**CONVERTIBLE—REAR WINDOW—SCRATCHED BY
THE REAR SEAT BACK LATCH**

**Article No.
91-20-3**

MERCURY: 1991 CAPRI

Figure 1 - Article 91-20-3

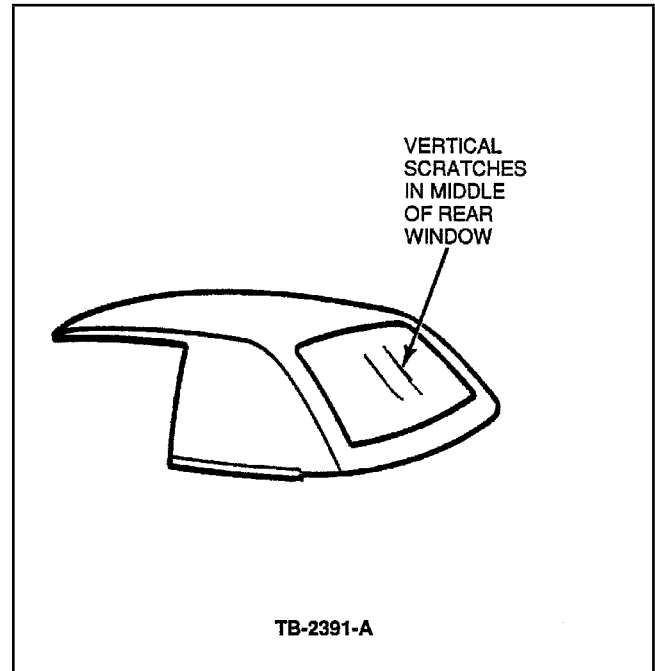
The rear window may be scratched when lowering the convertible top for stowage. This happens when the rear window passes the rear edge of the rear seat back latch.

Install three (3) protectors on the rear edge of the latch to prevent window scratches, Figure 1. Refer to the following procedure for service details.

Figure 2 - Article 91-20-3

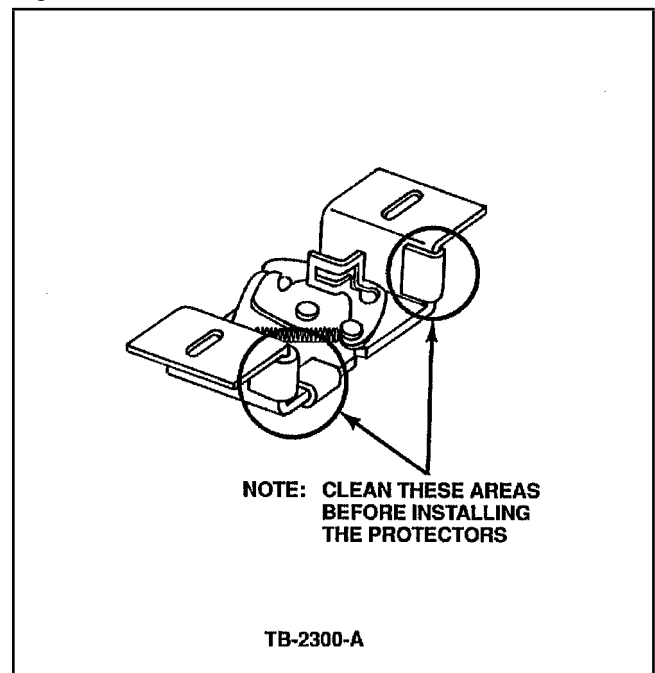
2. Clean the latch with a suitable solvent to remove any grease or foreign material and then dry.
3. Install three (3) protectors, complete with glue, on the rear edge of the latch as shown in Figure 2.
